Re: **Initial Submission Review -** High Point Dollar General – Site Plan Amendment
Case Number: 2021-6056-02

INITIAL SUBMISSION REVIEW

HIGH POINT - DOLLAR GENERAL
SITE PLAN

| 41. L1.01 - NOTES AND SCHEDULE | 83. P2.02 - SCHEDULE AND DETAILS |

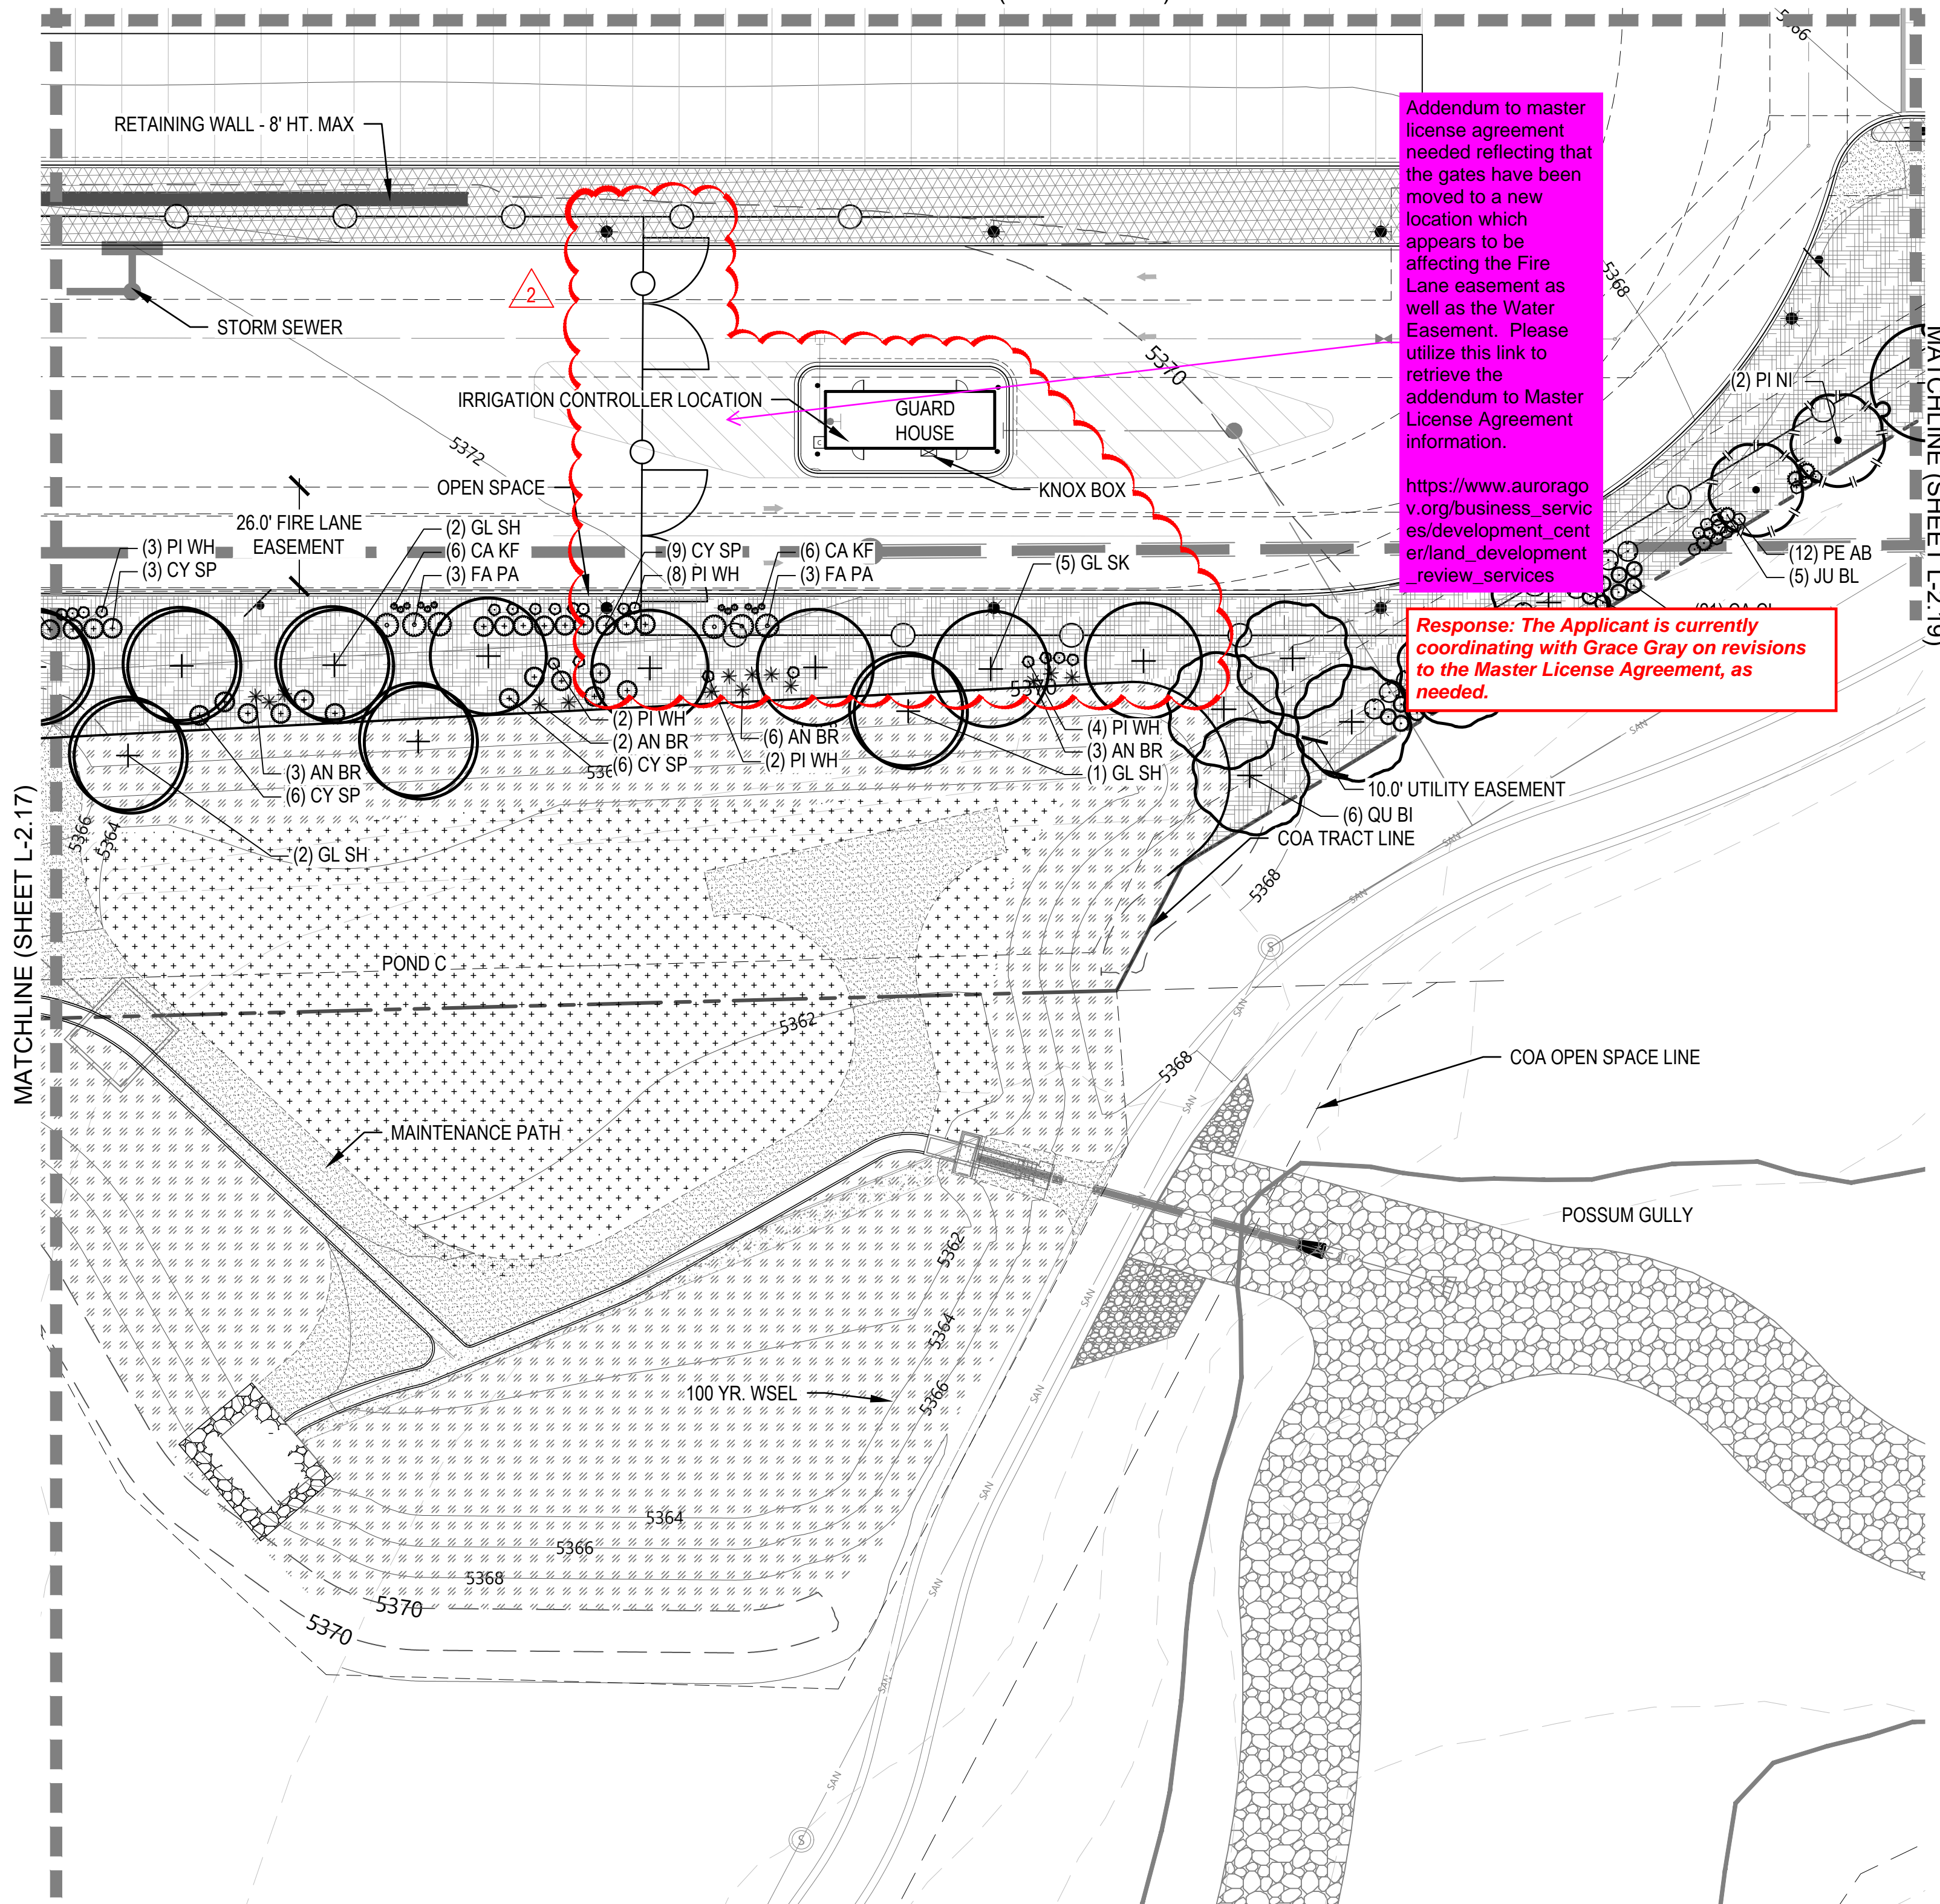
Please clarify if any plantings are being removed and update the plant schedule accordingly. If the total number isn't changing and these are simply being relocated, then this does not need to be clouded.

ND Response: Plant counts are changing due to updates in amenity area. There are 19 Bluestem grasses being added (AN BR) and 1 Kelseyi dogwood being added (CO KE). Previously, that change had been made, however the quantities in the plant schedule on this sheet had not been made which prompted this comment. The quantities are now updated to reflect the correct counts.

MATCHLINE (SHEET L-2.14)

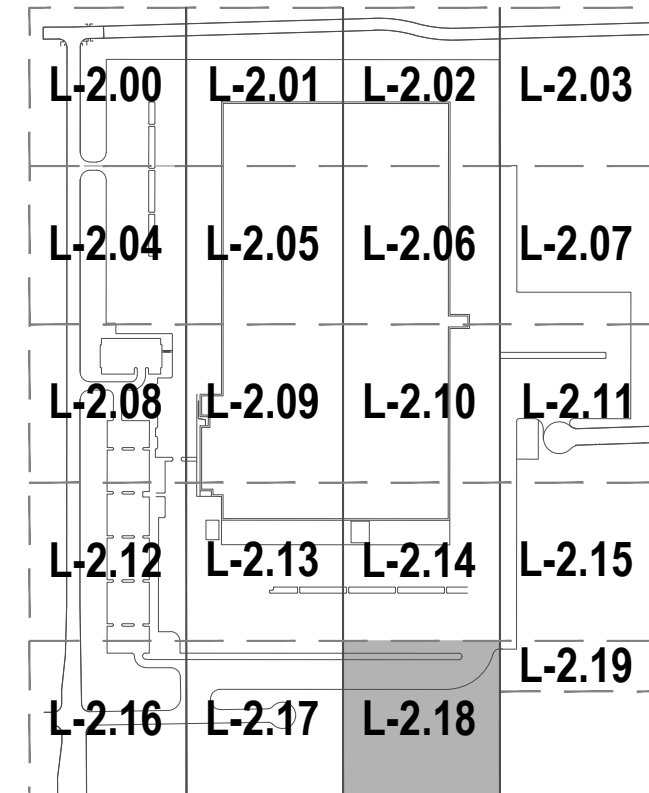
Addendum to master license agreement needed reflecting that the gates have been moved to a new location which appears to be affecting the Fire Lane easement as well as the Water Easement. Please utilize this link to retrieve the addendum to Master License Agreement information.

Response: The Applicant is currently coordinating with Grace Gray on revisions to the Master License Agreement, as needed.

2 BIKE RACK

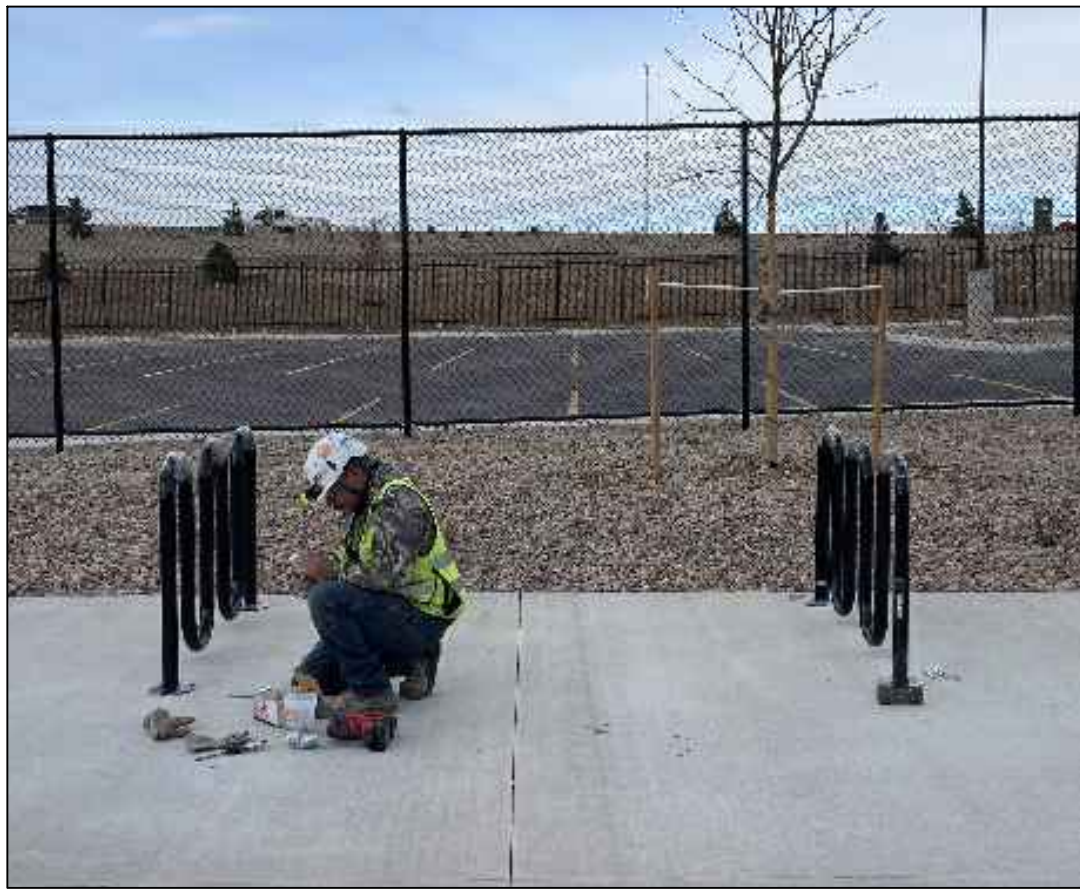
Please include a delta 2 along with this red cloud to show that U rack type is being changed.

Response: Delta 2 added.
